City of San Antonio
TRANSPORTATION AND CAPITAL IMPROVEMENTS

ADDENDUM NO. 4

PROJECT NAME: **Ray Ellison (Loop 410 to Old Pearsall Road)**

PROJECT NO.: **40-00312**

100 % SUBMITTAL	PROJECT NO.: 8185-00		DATE: 3/24/2015
DRWN. BY: HM	DSGN. BY: HM	CHKD. BY: DT	SHEET NO.: 4

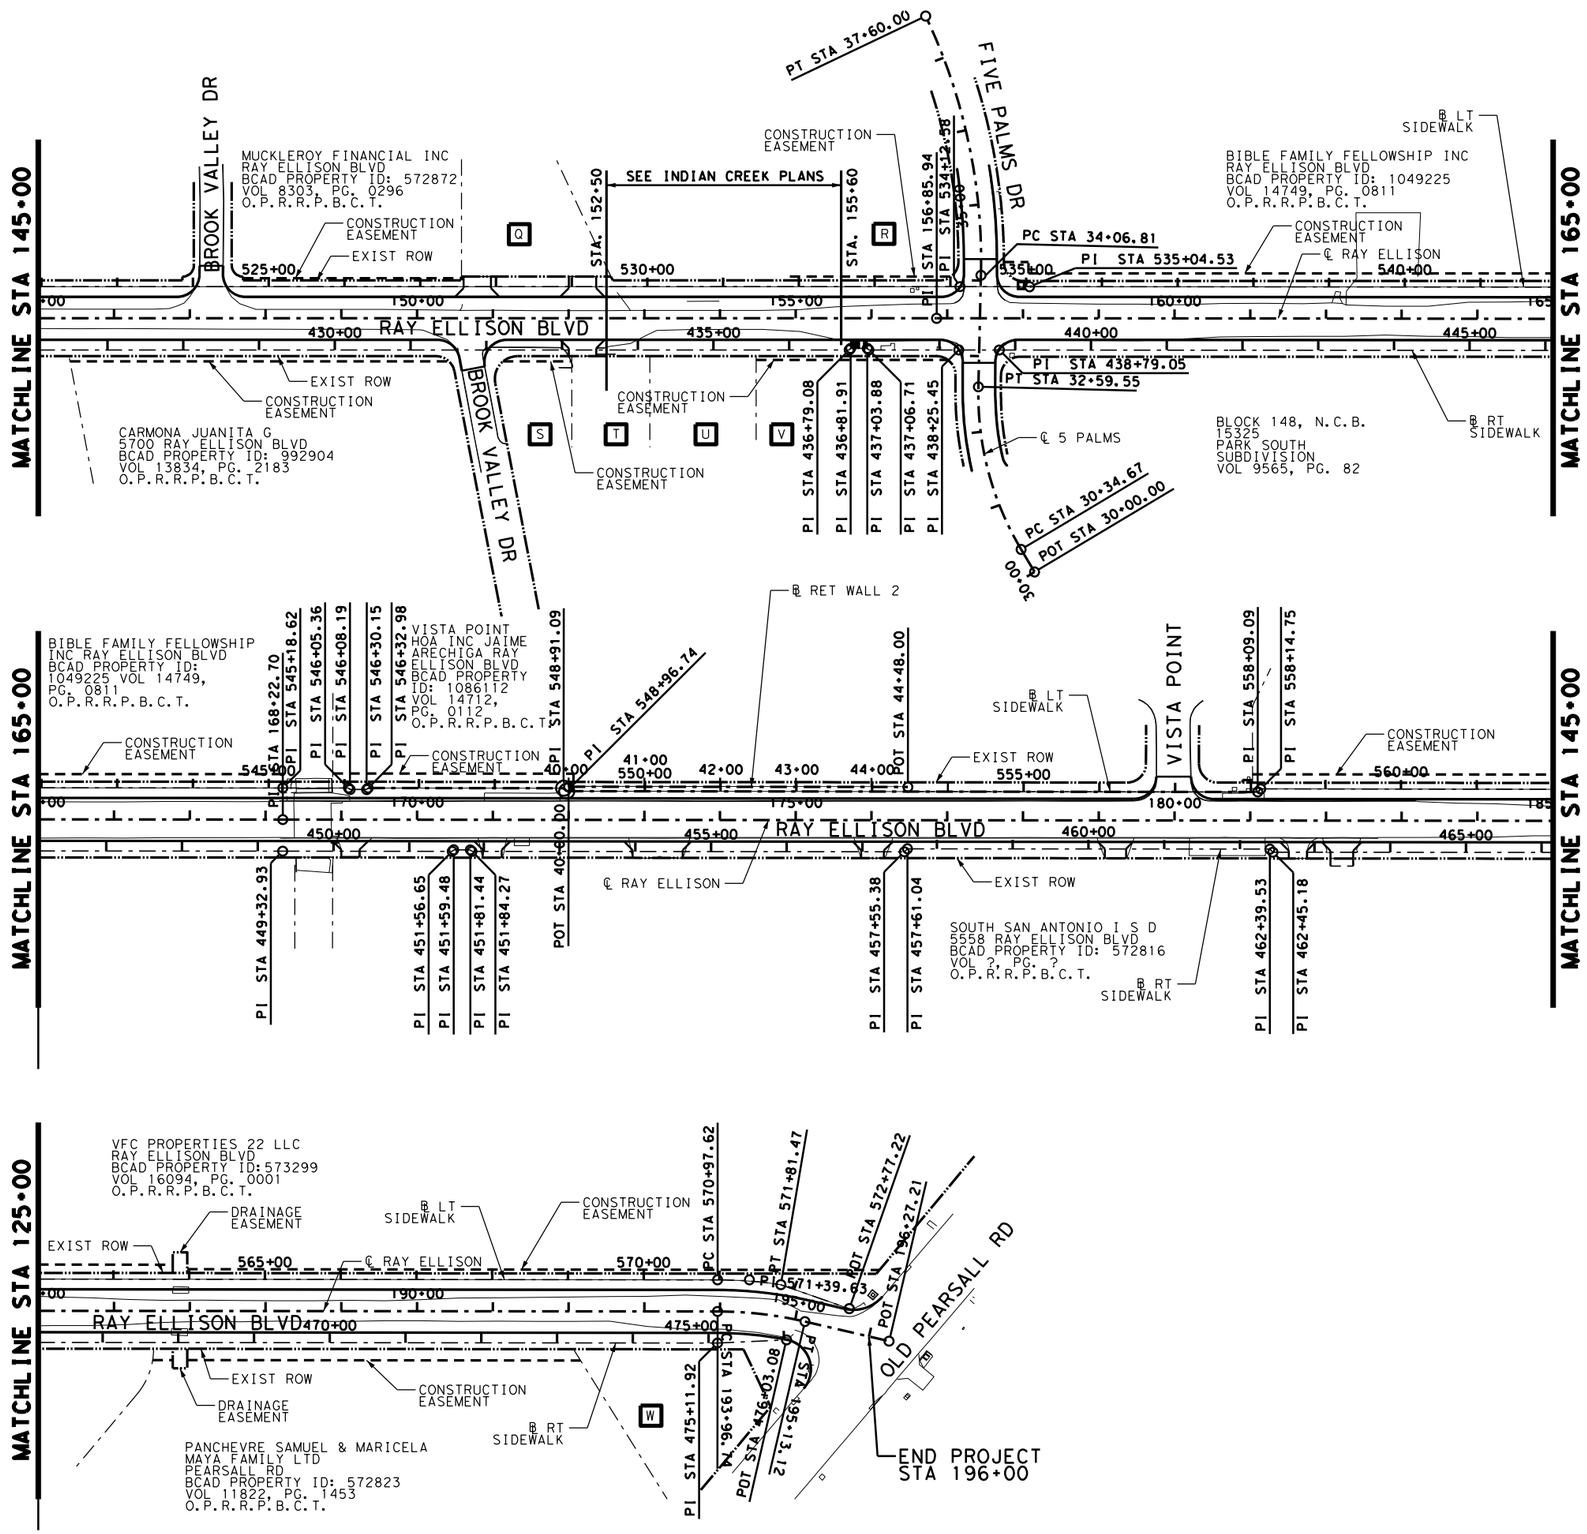
- Replace Sheet 4 "Project Layout" with Addendum No. 4 Sheet 4 "Project Layout" Revised alignments.

100 % SUBMITTAL	PROJECT NO.: 8185-00		DATE: 3/24/2015
DRWN. BY: HM	DSGN. BY: HM	CHKD. BY: DT	SHEET NO.: 39

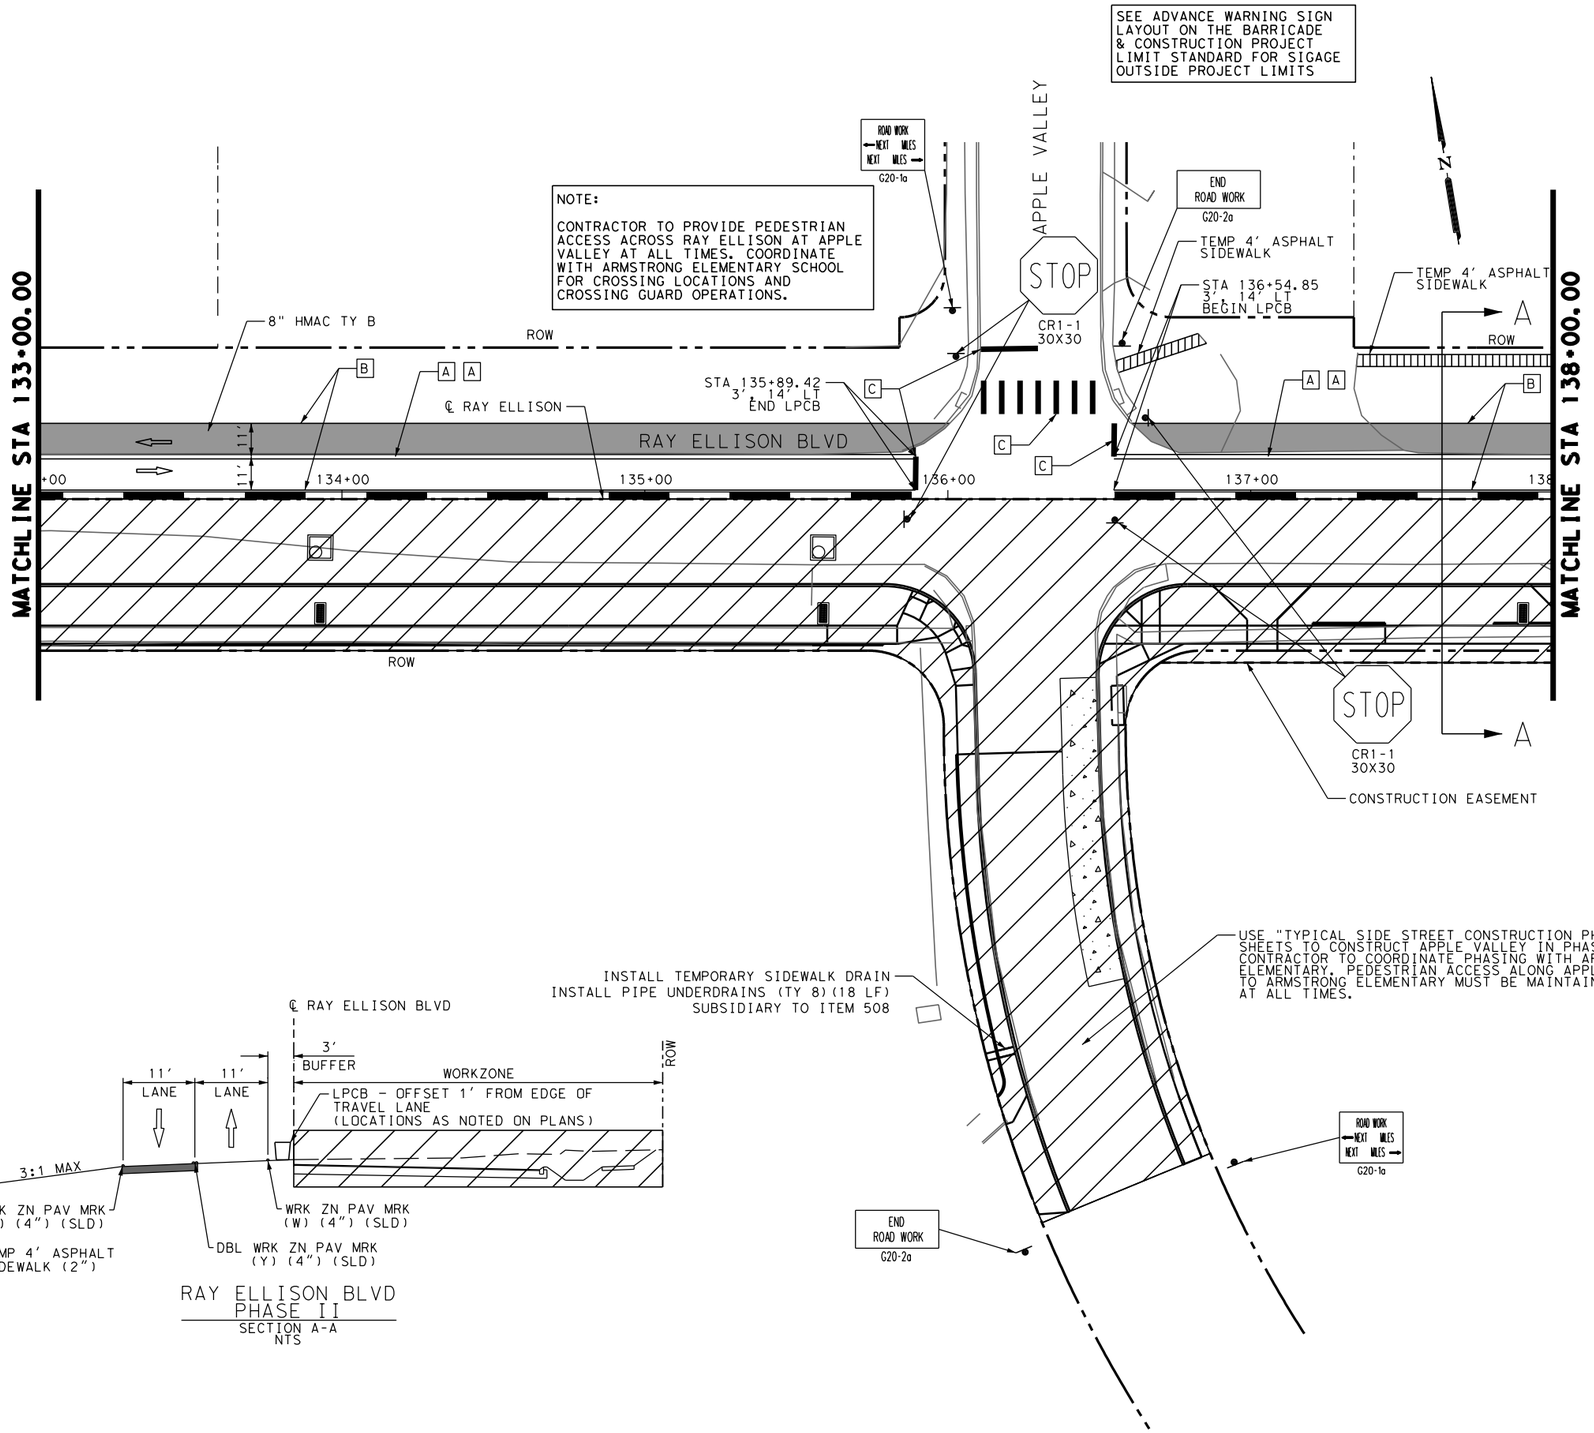
- Replace Sheet 24 “Summary of Quantities Traffic Signal” with Addendum No. 4 Sheet 24 “Summary of Quantities Traffic Signal” Updated quantities.
- Replace Sheet 39 “Traffic Control Plan Layout Phase 2” with Addendum No. 4 Sheet 39 “Traffic Control Plan Layout Phase 2” Revised typical section.

17. TCP Phase II sheets show a 4" temporary sidewalk in the cross section, yet calls out a 2" depth in the legend. Which depth is correct?

Response: All temporary sidewalks will have 2" depth. TCP sheets are revised for Addendum 04.

100 % SUBMITTAL	PROJECT NO.: 8185-00		DATE: 3/24/2015
DRWN. BY: HM	DSGN. BY: HM	CHKD. BY: DT	SHEET NO.: 40

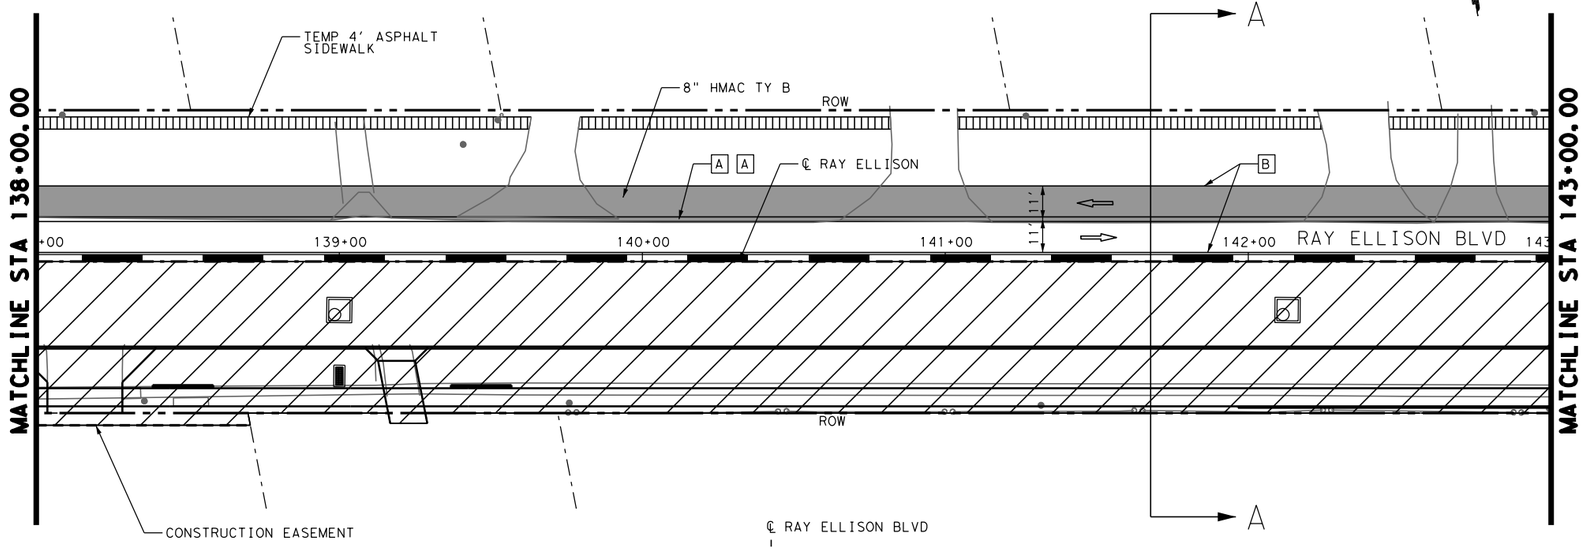
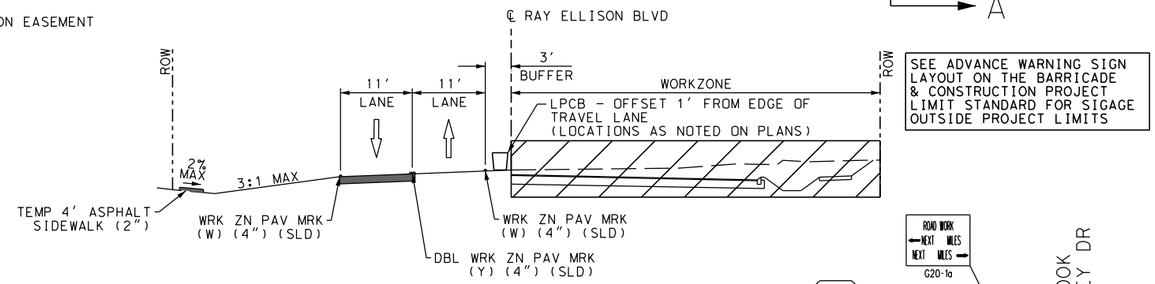
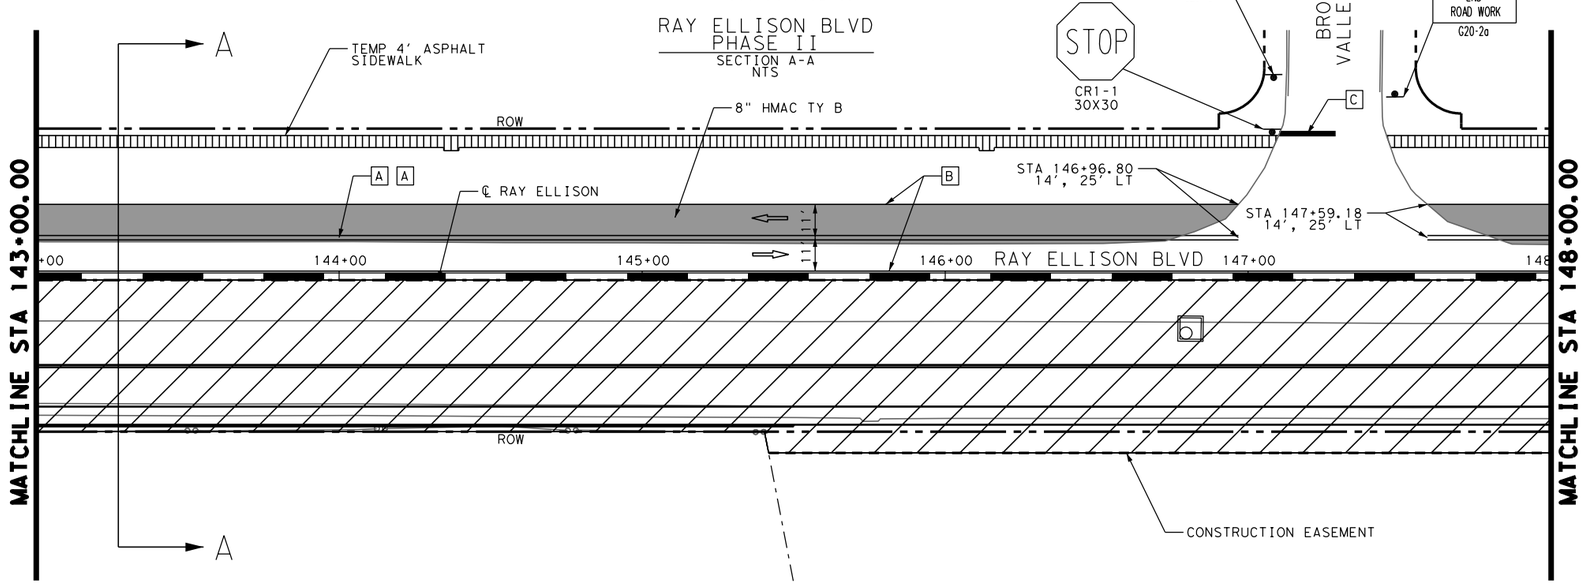
- Replace Sheet 40 “Traffic Control Plan Layout Phase 2” with Addendum No. 4 Sheet 40 “Traffic Control Plan Layout Phase 2” Revised typical section.
- Replace Sheet 41 “Traffic Control Plan Layout Phase 2” with Addendum No. 4 Sheet 41 “Traffic Control Plan Layout Phase 2” Revised typical section.

100 % SUBMITTAL	PROJECT NO.: 8185-00		DATE: 3/24/2015
DRWN. BY: HM	DSGN. BY: HM	CHKD. BY: DT	SHEET NO.: 42

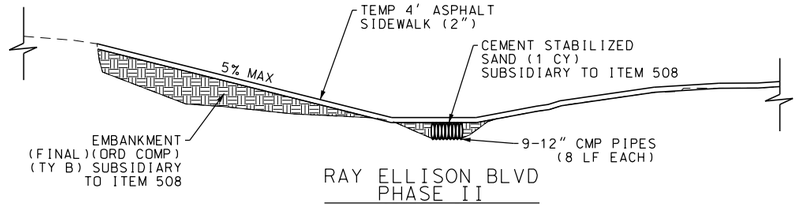
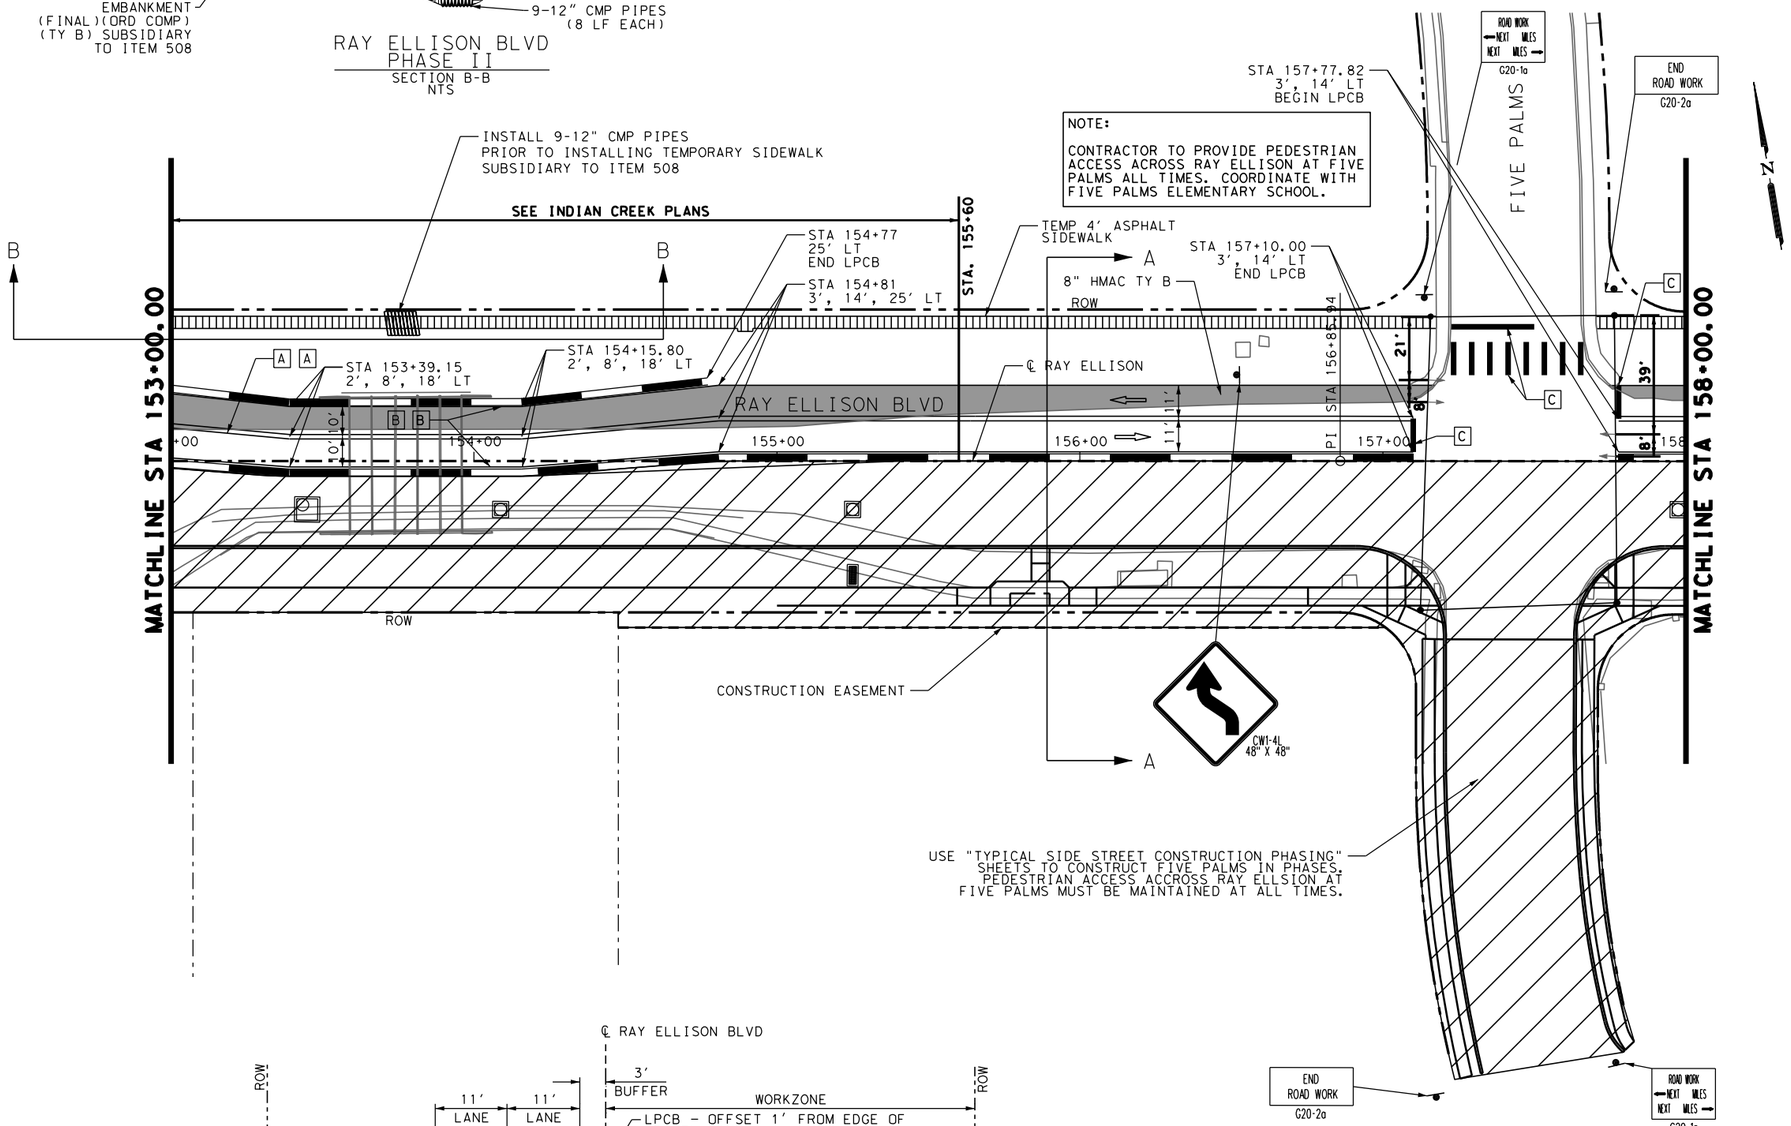
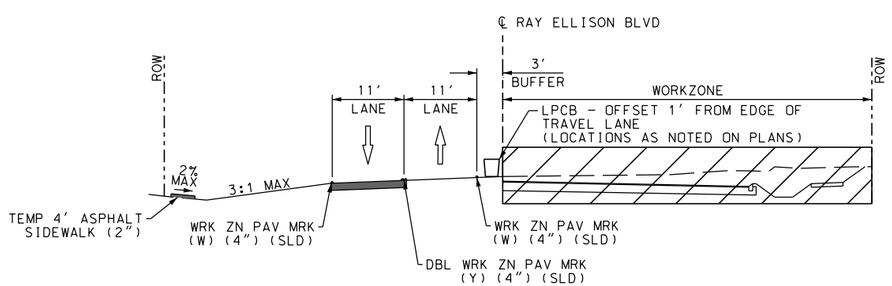
- Replace Sheet 42 “Traffic Control Plan Layout Phase 2” with Addendum No. 4 Sheet 42 “Traffic Control Plan Layout Phase 2” Revised typical section.
- Replace Sheet 43 “Traffic Control Plan Layout Phase 2” with Addendum No. 4 Sheet 43 “Traffic Control Plan Layout Phase 2” Revised typical section.
